UL924 INSTALLATION ADDENDUM

In addition to the standard install guide and manual supplied for the Powerware 9155, 9355 & 9390 series UPS. Please review this addendum; it contains a listing of specific changes made to meet all UL924 Emergency Lighting System requirements.

FIGURE 1

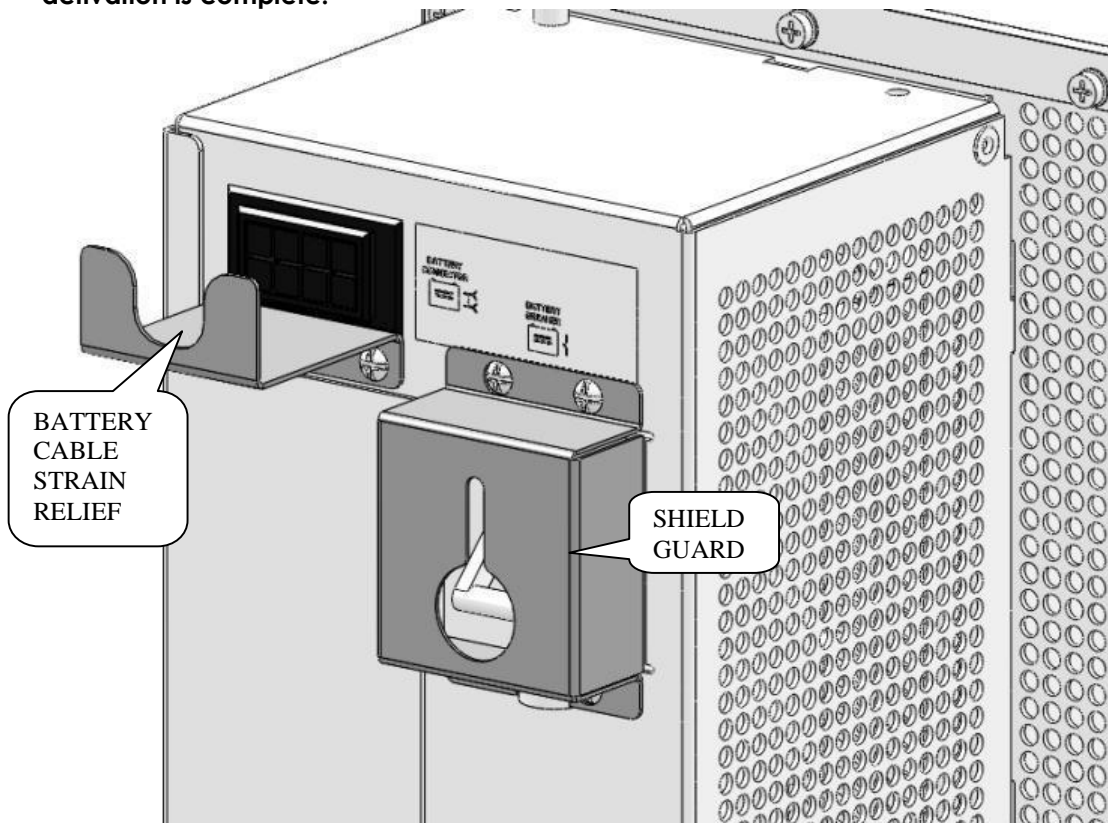
Shield Guard over any exposed circuit breakers, the DC breaker on the back of each battery cabinet and the 2 breakers on the UPS (one DC breaker and one input breaker). This Shield Guard requires a small tool to disconnect (open) but can be switched on by a finger. Mechanical BATTERY CABLE STRAIN RELIEFs are also added on all 15KVA and below systems to DC Battery connectors which are supplied and are required to be re-installed before system activation is complete.

FIGURE 2

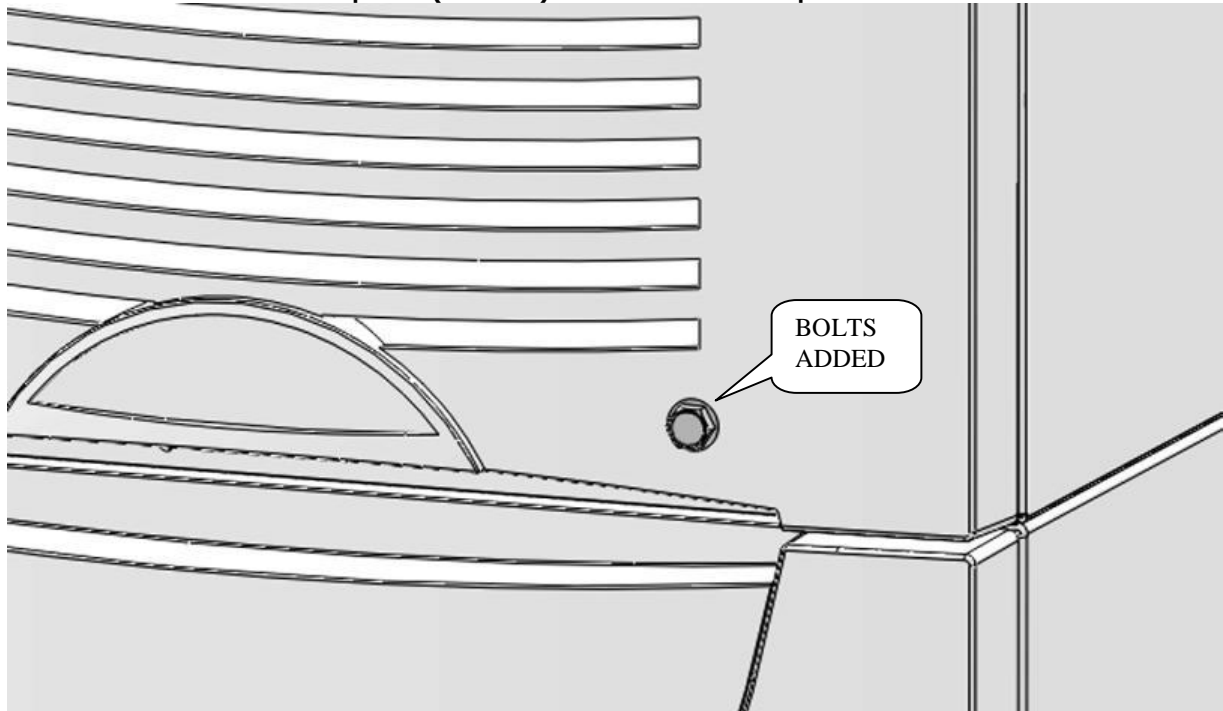
Bolts added to secure front panel (or Bezel) which otherwise exposes a means of disconnect

FIGURE 3

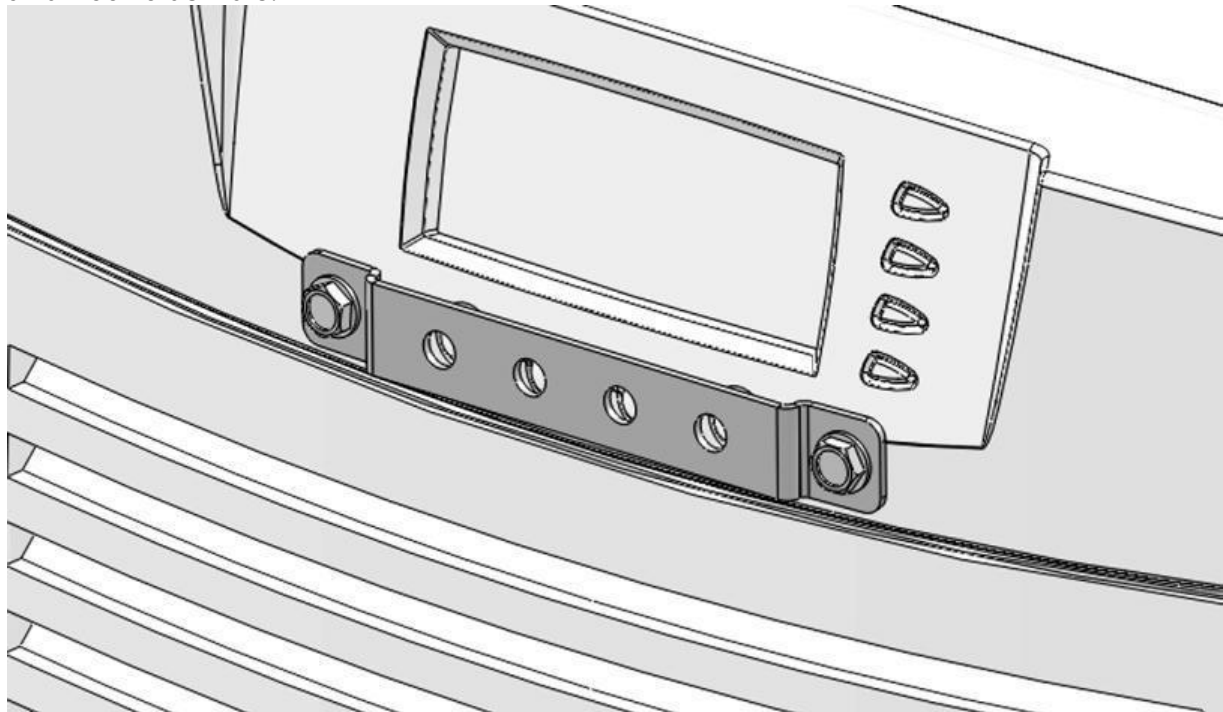
SHIELDED BRACKET installed over front panel display buttons which require a pen tip or other small tool to activate.

FIGURE 4

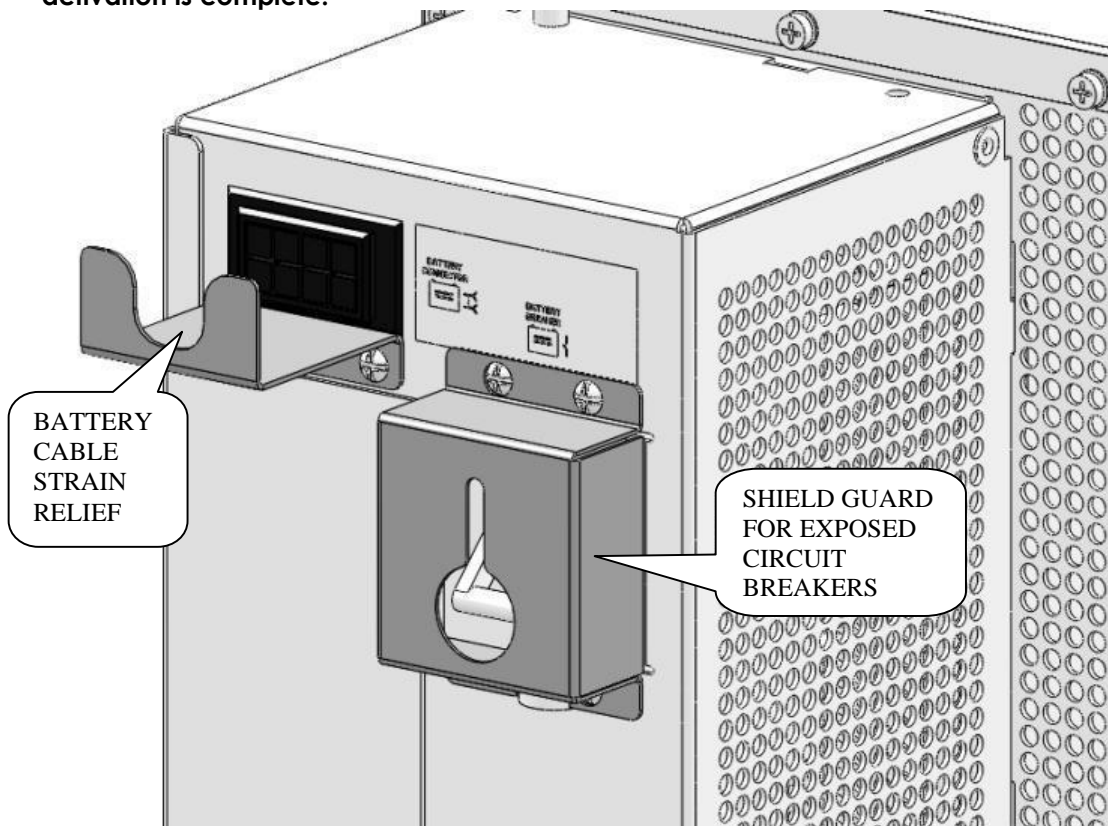
Shield Guard over any exposed circuit breakers, the DC breaker on the back of each battery cabinet and the 2 breakers on the UPS (one DC breaker and one input breaker). This Shield Guard requires a small tool to disconnect (open) but can be switched on by a finger. Mechanical BATTERY CABLE STRAIN RELIEFs are also added on all 15KVA and below systems to DC Battery connectors which are supplied and are required to be re-installed before system activation is complete.

FIGURE 5

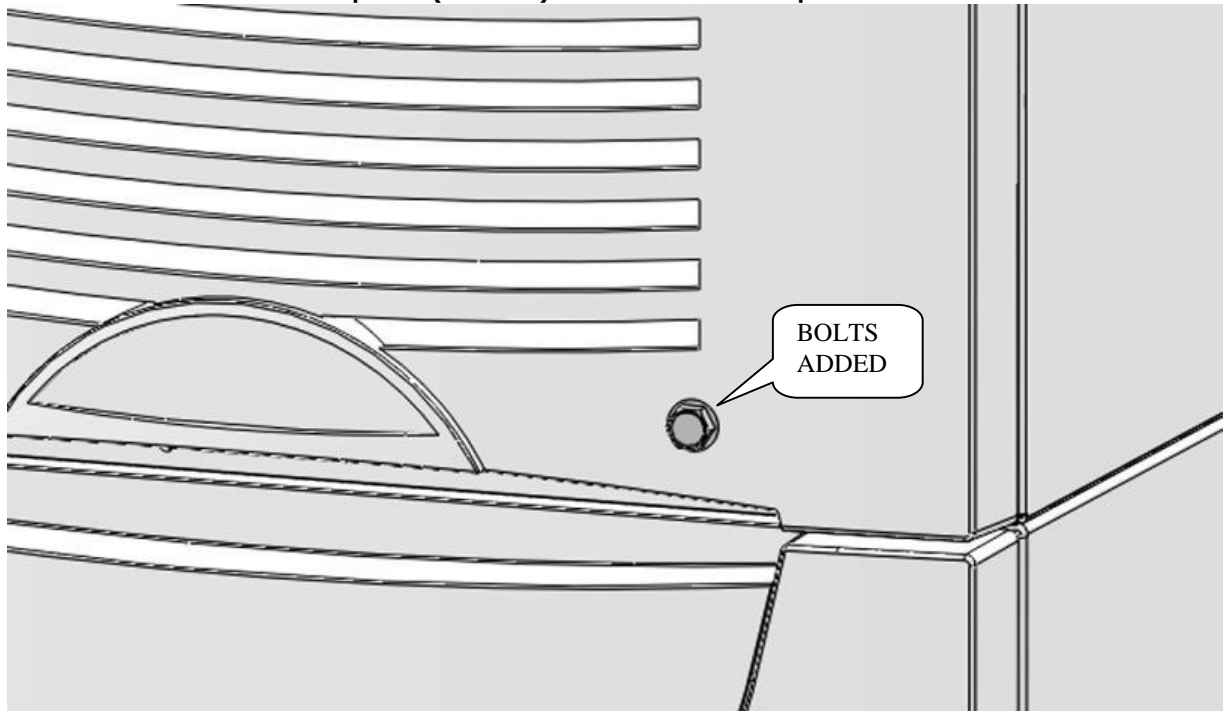
Bolts added to secure front panel (or Bezel) which otherwise exposes a means of disconnect

FIGURE 6

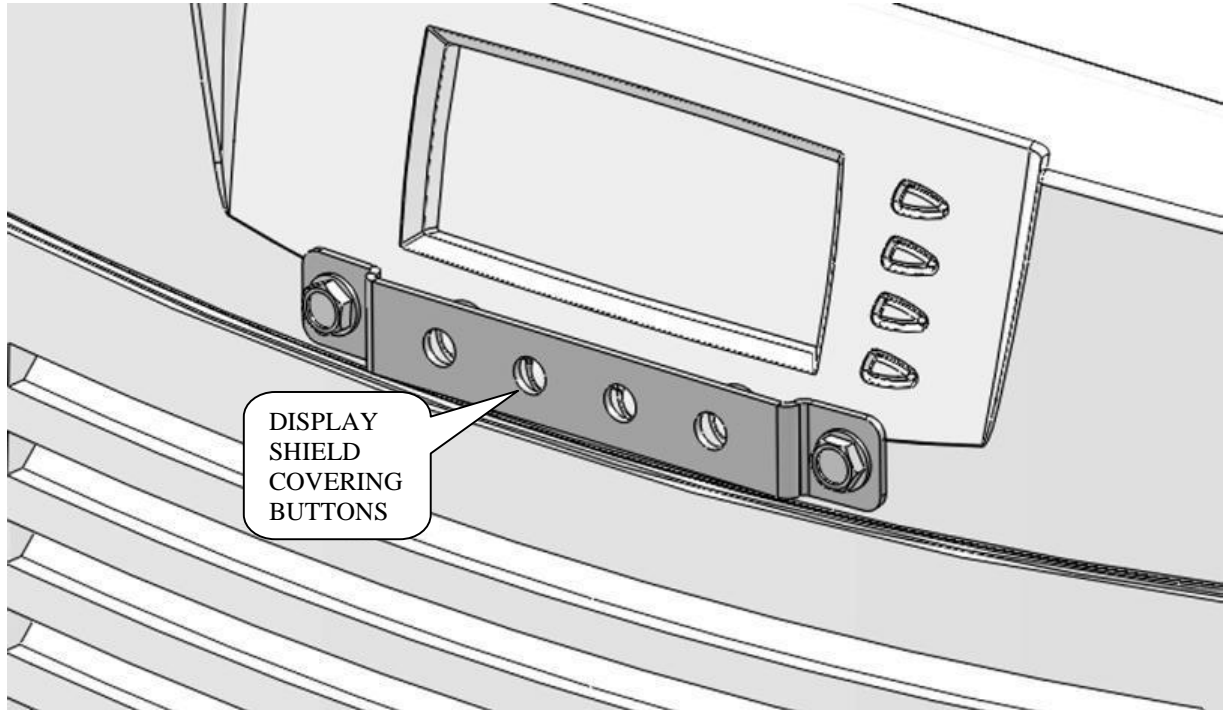
SHIELDED BRACKET installed over front panel display buttons which require a pen tip or other small tool to activate.

FIGURE 7

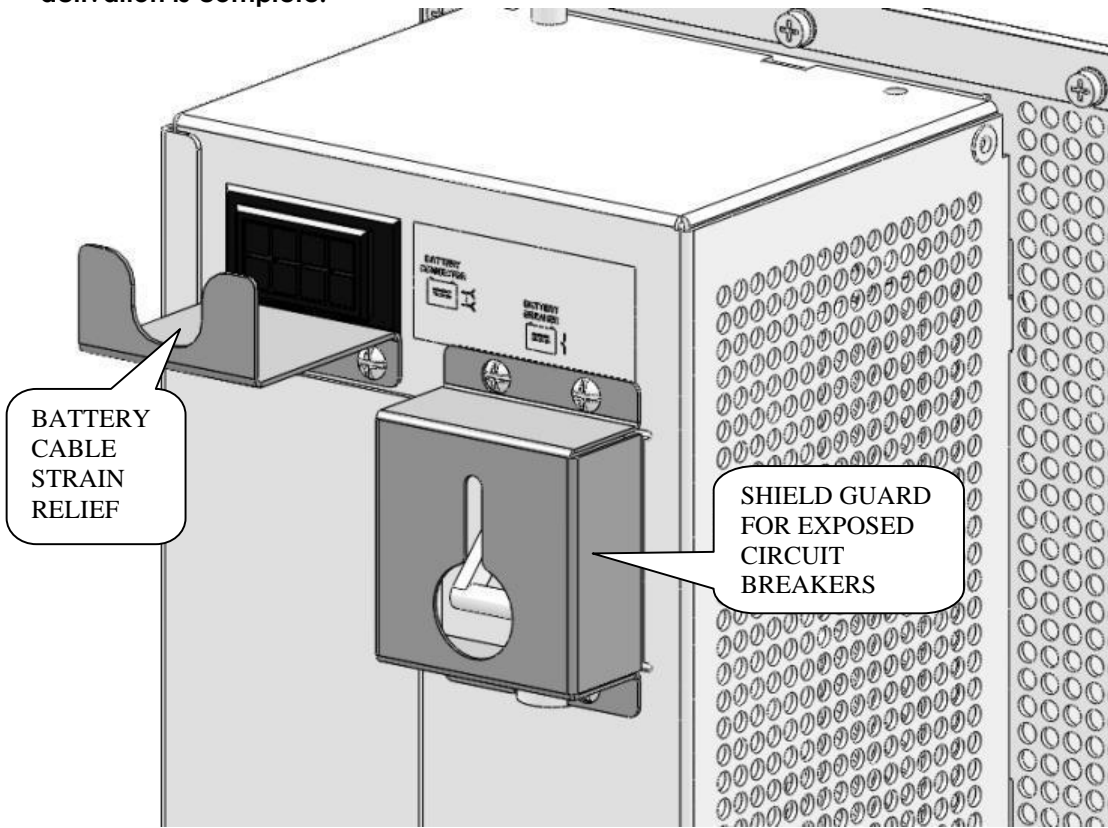
Shield Guard over any exposed circuit breakers, the DC breaker on the back of each battery cabinet and the 2 breakers on the UPS (one DC breaker and one input breaker). This Shield Guard requires a small tool to disconnect (open) but can be switched on by a finger.

Mechanical BATTERY CABLE STRAIN RELIEFS are also added on all 15KVA and below systems to

DC Battery connectors which are supplied and are required to be re-installed before system activation is complete.

FIGURE 9

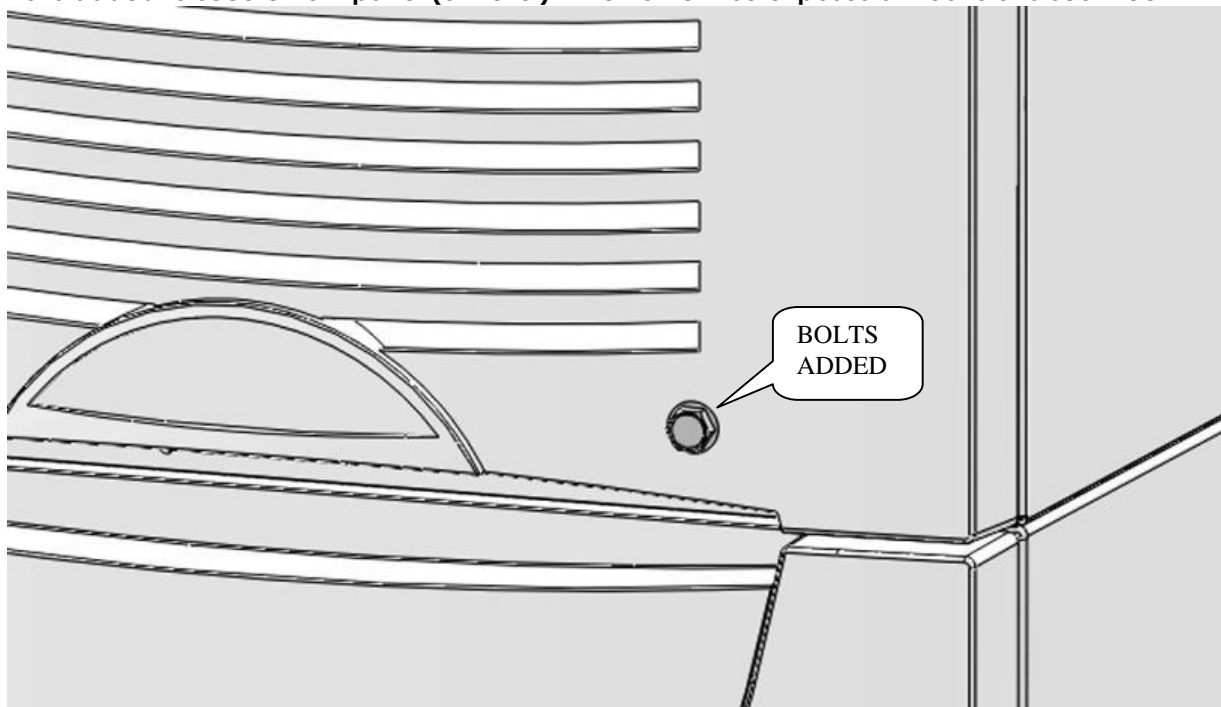
Bolts added to secure front panel (or Bezel) which otherwise exposes a means of disconnect

FIGURE 10

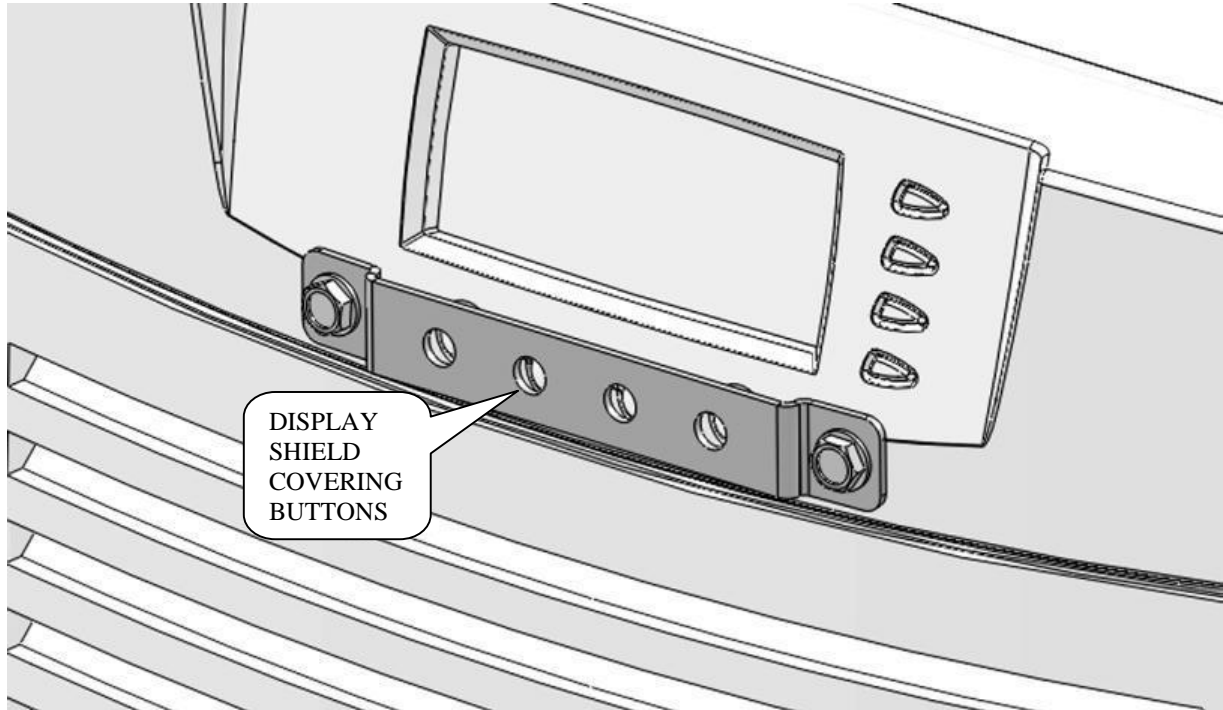
SHIELDED BRACKET installed over front panel display buttons which require a pen tip or other small tool to activate.

FIGURE 11

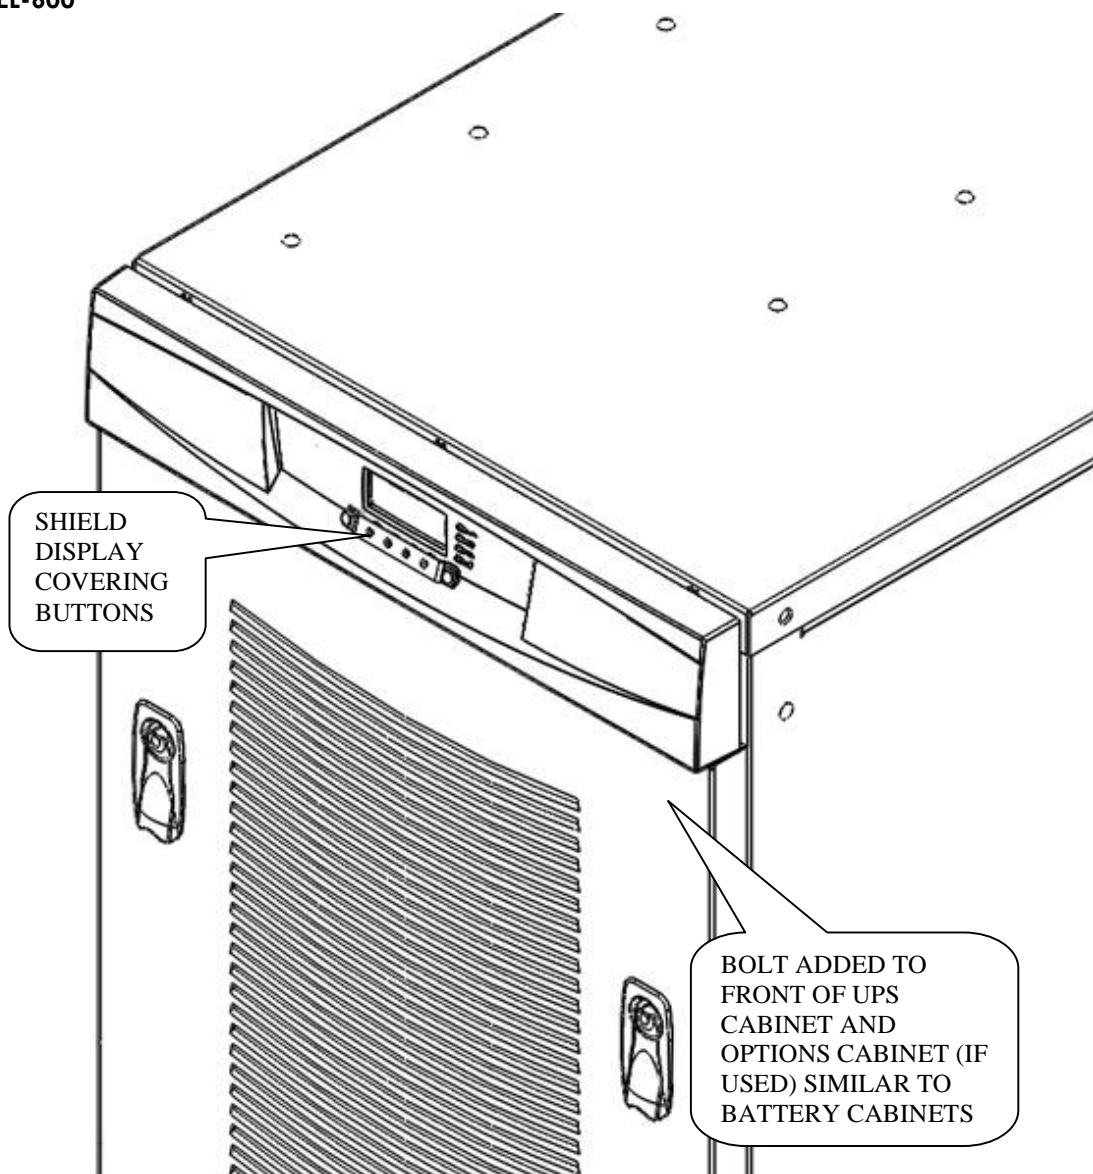
Shielded bracket over front panel display buttons, or recessed buttons, either of which require a pen tip or other small tool to activate. (See FIGURE 11)

Front panel has Bolts added (similar to all Extended Battery Cabinets) which otherwise exposes a means of disconnect via Service Bypass Switch.

FIGURE 12

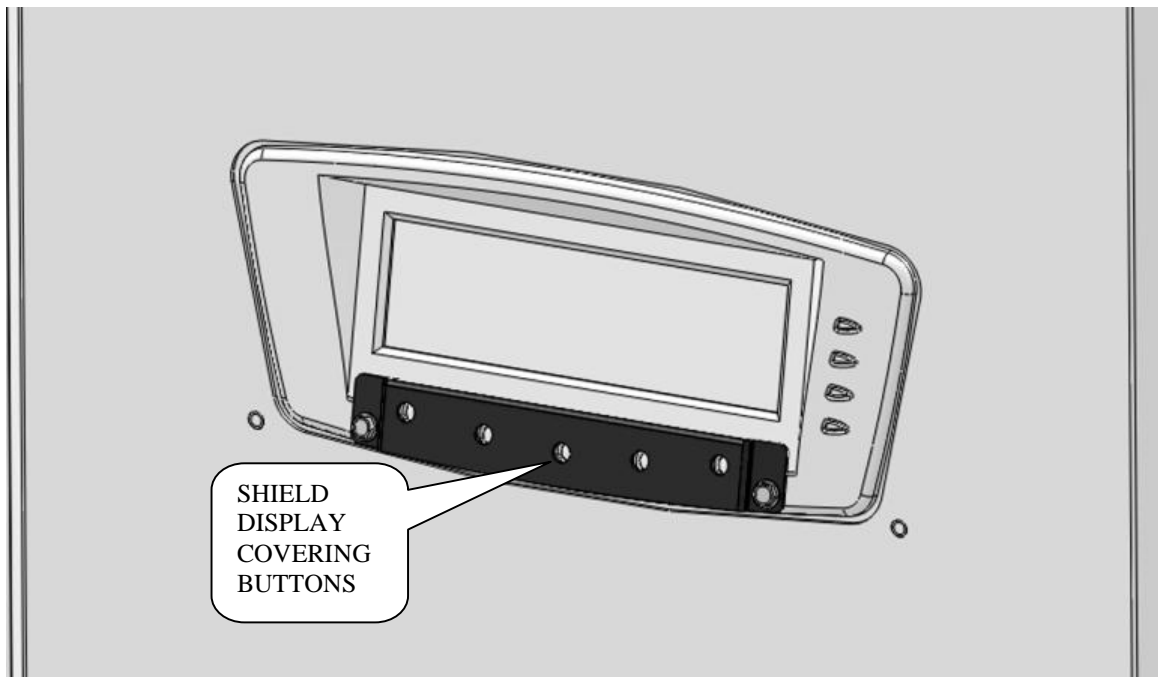
Shielded bracket over front panel display buttons, or recessed buttons, either of which require a pen tip or other small tool to activate. (See FIGURE 12)
